**SUBJECT:** COMANCHE PEAK NUCLEAR POWER PLANT, UNITS 3 AND 4  
DOCKET NUMBERS 52-034 AND 52-035  
SUPPLEMENTAL INFORMATION FOR RESPONSE TO REQUEST FOR ADDITIONAL  
INFORMATION NO. 4206

**RAI NO.: 4206 (CP RAI #135)**

**SRP SECTION: 12.03-12.04 - Radiation Protection Design Features**

**QUESTION NO.: 12.03-12.04-11**

FSAR Rev 1 Figure 11.2-201 Sheet 10

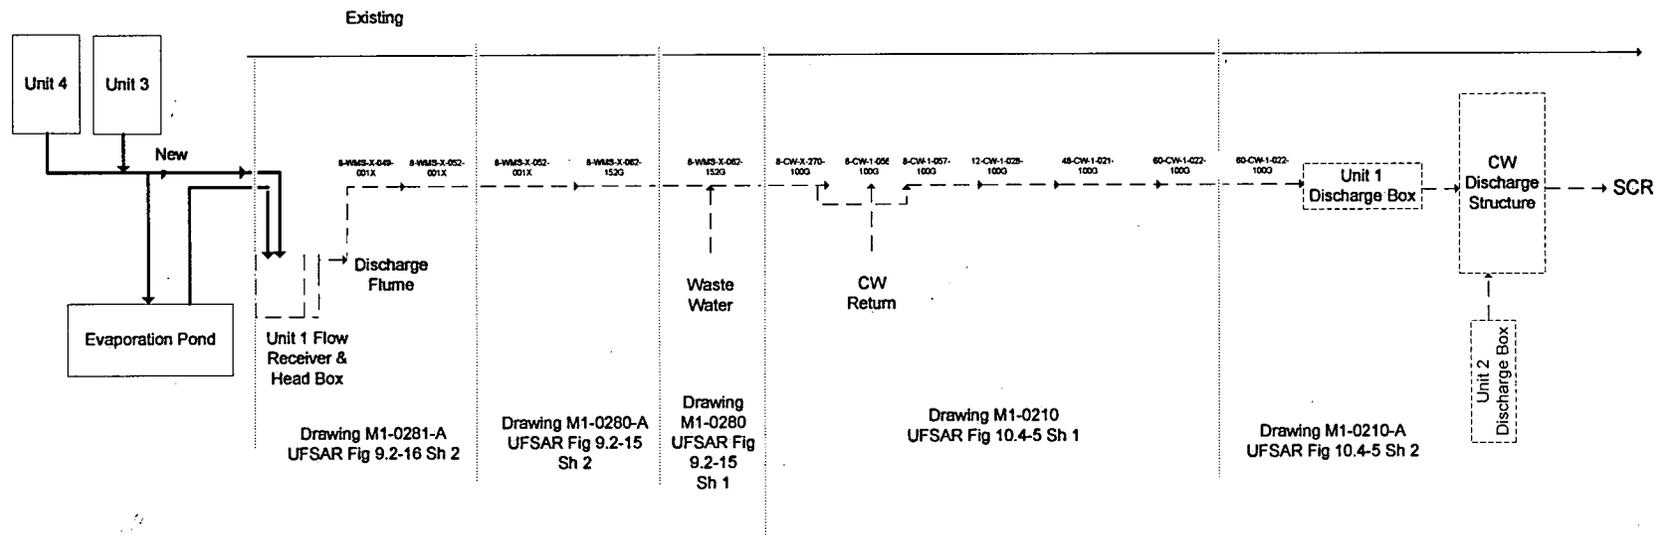
The applicant was asked to describe the provisions for those portions cooling water systems, down stream of the Liquid Waste Processing System (LWPS) connection points. While the applicant noted that evaporation pond piping would use leakage detection and inspection ports, neither this response, nor the response to RAI No. 2747 (CP RAI # 29), Question 11.02-2, dated September 24, 2009, noted this provision in the COL FSAR changes. This response also does not address the piping down stream of where the discharge piping from the evaporation pond connects to the cooling water discharge piping. The "Liquid Radioactive Release Lessons Learned Task Force Final Report" describes industry-operating experience involving inadvertent releases from cooling water piping or components located down stream of LWPS connections.

1. The treated effluent from Units 3 and 4 and the radwaste evaporation pond are piped directly to the Unit 1 flow receiver and head box (see attached FSAR Figure 11.2-201 Sheet 10). The effluent from the Unit 1 flow receiver and head box flows to the Unit 1 discharge flume, then through existing Unit 1 piping to the Unit 1 circulating water system, and then to Squaw Creek Reservoir (SCR). This was addressed in FSAR Subsection 11.2.2 by response to RAI No. 2747 (CP RAI #29) on September 24, 2009 (ML092720676) and is included for convenience below:

The treated liquid effluents released from the CPNPP Units 3 and 4 and the evaporation pond are piped directly into the Unit 1 Waste Management System (WMS) flow receiver and head box, which includes the discharge flume. The effluents enter from the top of the receiver and head box and are above the liquid level in the box so that they flow freely into the box, from where the content flows to the Unit 1 WMS discharge flume, and by gravity to the Unit 1 Circulating Water System (CWS), via an existing Unit 1 pipeline connecting the WMS to the CWS. At this pipeline intersection, the Unit 3 and 4 treated effluent and the Unit 3 and 4 evaporation pond effluents are commingled with various Unit 1 and 2 waste effluent streams. This Unit 1 circulating water flow path then goes to the Unit 1 condenser water box outlet, where it joins the Unit 2 condenser water box outlet flow. The joined flows from the Unit 1 and 2 condenser water boxes are then sent to the SCR via the Unit 1 and 2 discharge tunnel and outfall structure from all four units (see Figure 11.2-201 Sheet 10 for a visual representation of the above described flow path.)
